# TDA flexure to fiber gap margin and interference problem

## Trade Study notes

# Anti-Coincidence Detector

### Report to SLAC on Nov. 18, 2003

# Tile Spacing Issue – Worst Care

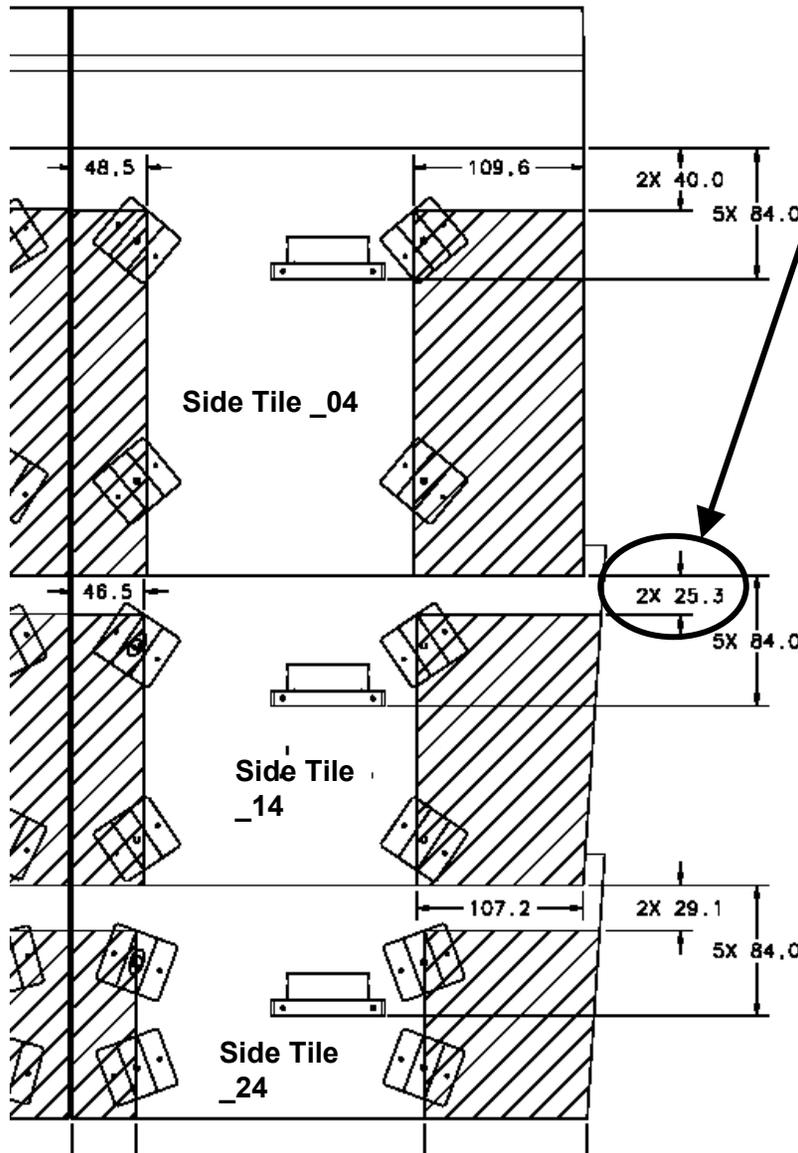
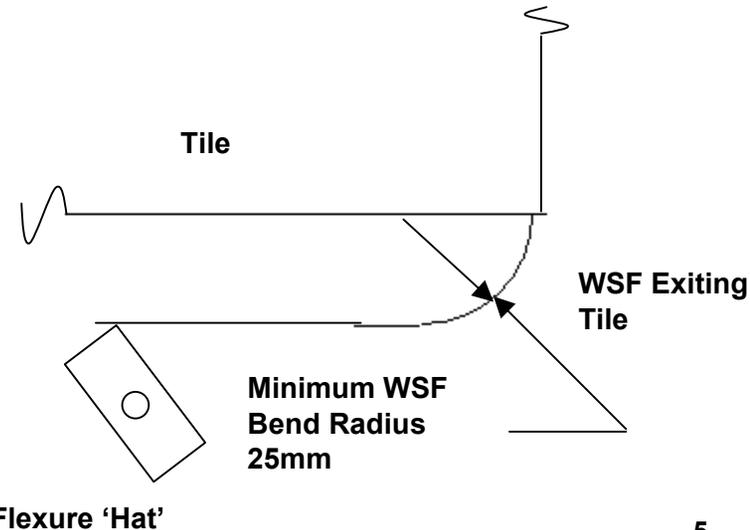
## **•BIGGEST CHALLENGE**

**•Spacing Between Crown Tile (Row 1) and Row 2 Tile Flexure (Upper) :**

**•25mm WSF Bend Radius Spacing was the Design at the Time Issue Was Found**

**•Brings the WSF too Close to Tile Flexures.**

# Tile Spacing Issue Solution

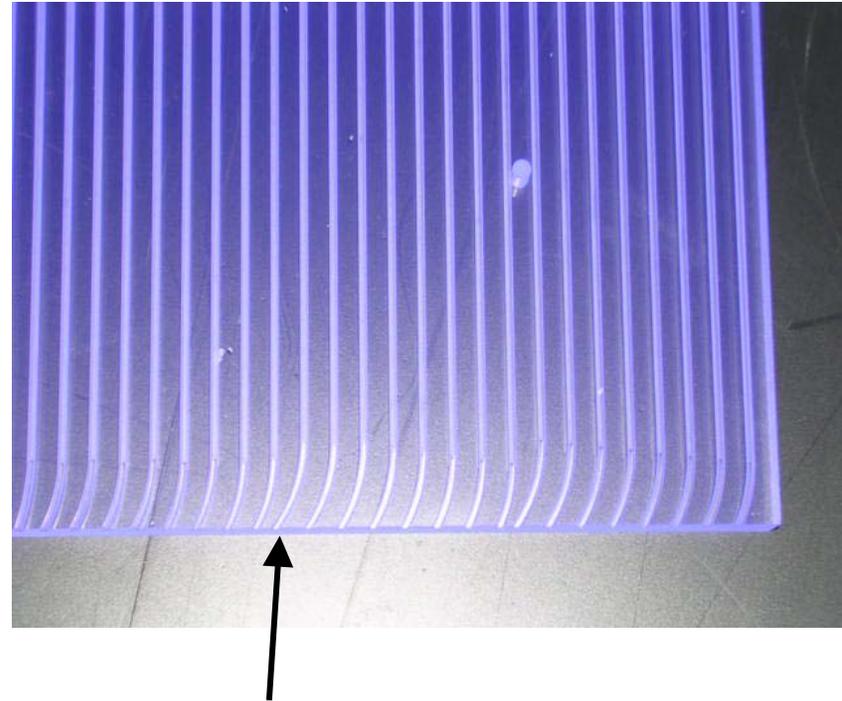
Instead of WSFs Exiting Straight Out Tile Edge (Prior Design), a Groove in the Tile Initiates the WSF Curve 20mm Sooner.

- ✓ Establish Design Envelope Between TDAs and TSA Mounts.
  - ✓ Worked With FERMI to Establish Acceptable TDA Envelope
    - ✓ FERMI Changed How the Fibers Exit the Tile
- ✓ Moved Upper TSA Flexure Mounts 5mm for Row 3 TDAs
  - ✓ Tile Edge to Tile Flexure is Now 30.3mm

# TDA Envelope Drawing

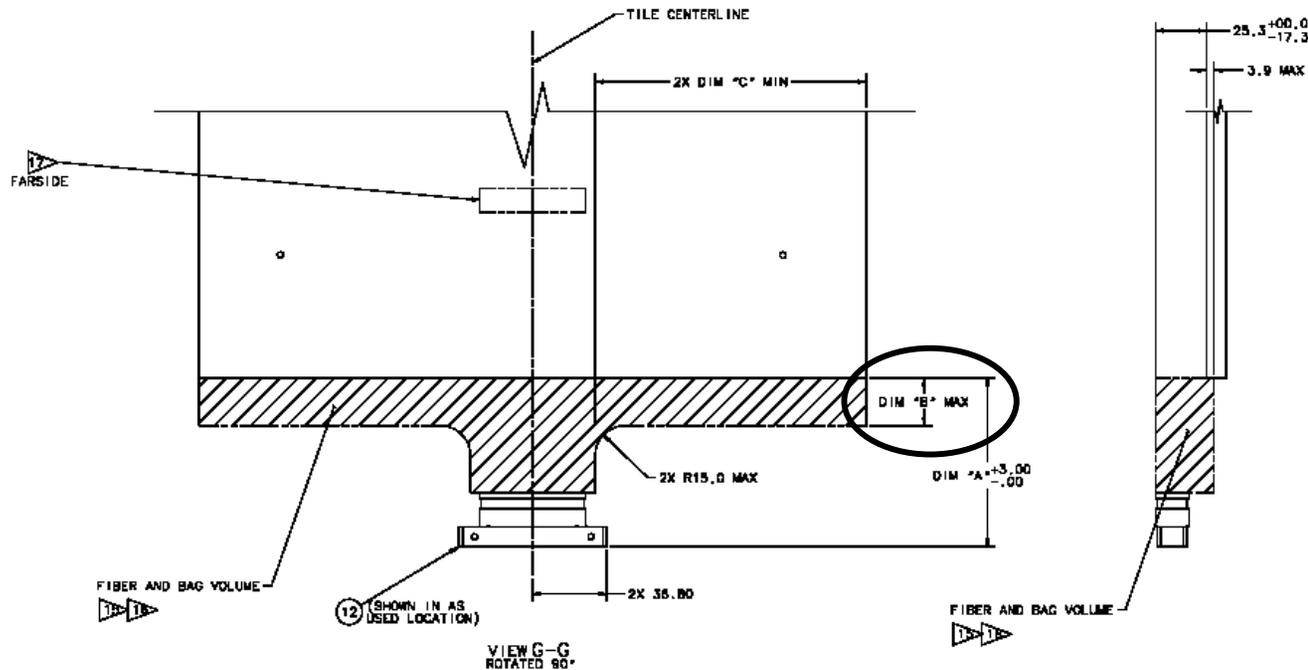
THIS IS SHEET 7 OF EO GD2054511 REV -  
ADD SHEET, TABLE1 AND VIEWS AS FOLLOWS:

- Revised TDA Drawings to Define TDA / WSF Envelope

- Conforms the Numbers (Dim B) FERMI Demonstrated and Agreed with.

- Smallest Tile to WSF Envelope (X-Hatch) Dim 'B' is now 23.7mm (MAX)
- Smallest Tile Edge to Tile Flexure is now 29.1mm
- Minimum of 5.6mm Clearance is now Achieved.

# 3<sup>rd</sup> Row TDA WSF to Bottom Tile Flexure Interference

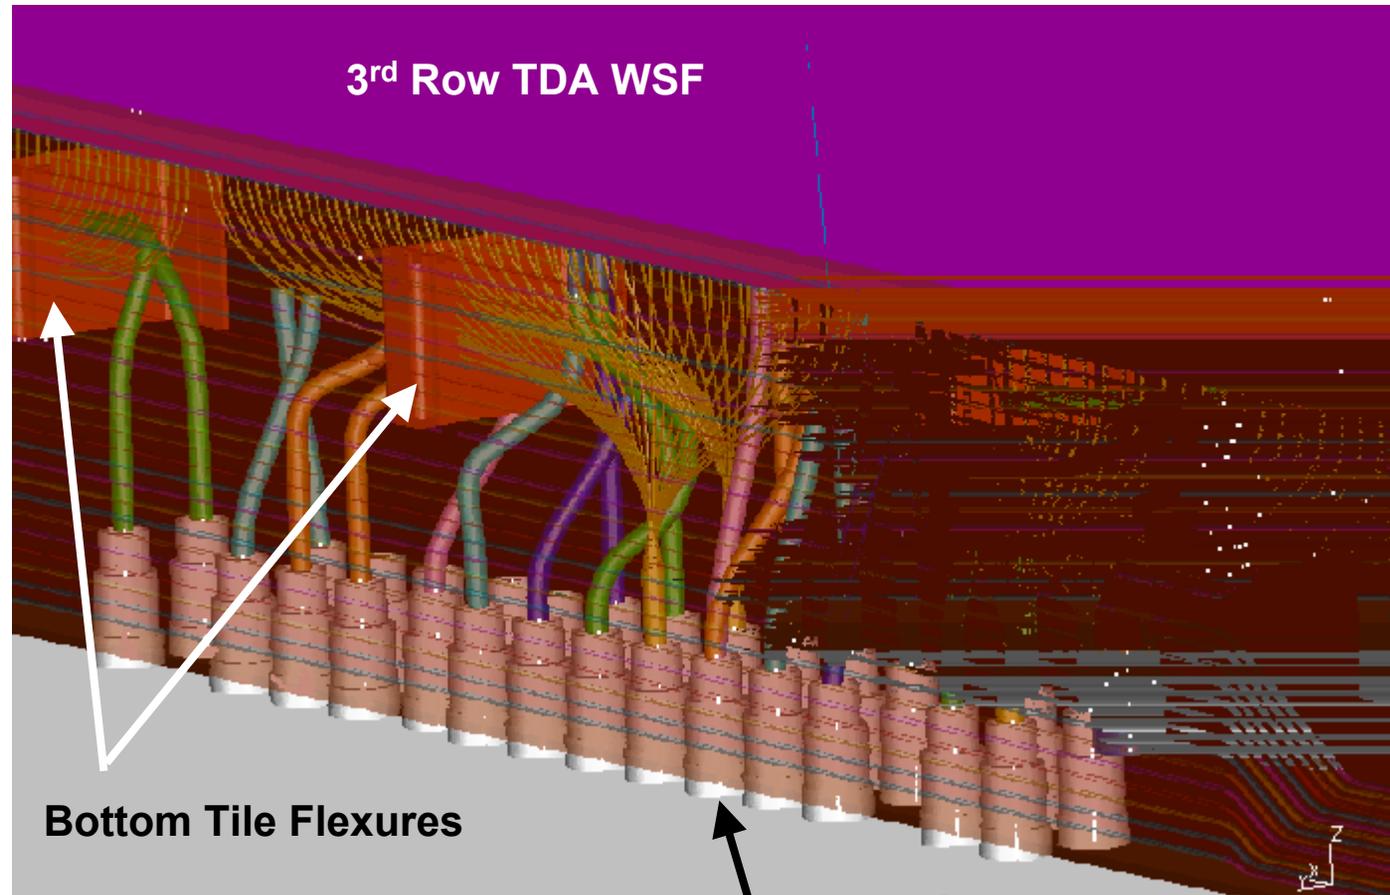
- The Bronze Colored WSF Interfere with the Bottom Tile Flexures Shown

- Note: The WSF terminate directly into the PMTs
